# Service Bulletin

## 2001-2004 GL1800/A Trunk Opener Unit

### PART DESCRIPTION

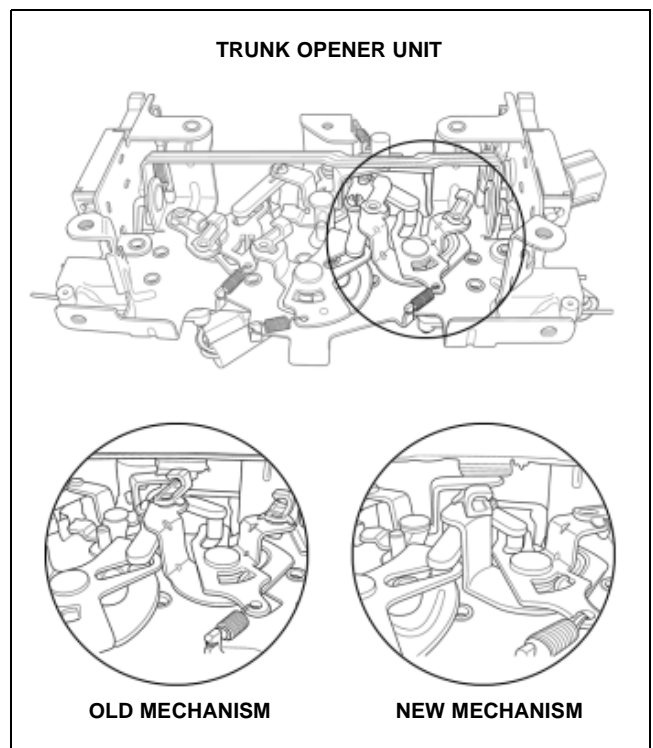
Some customers may experience trunk or saddlebag lids not opening when the corresponding latch lever is pulled.

To correct this condition, the opener mechanism must be replaced with a new opener mechanism.

**Opener Unit**  
P/N: 81310-MCA-A22  
H/C: 7700768
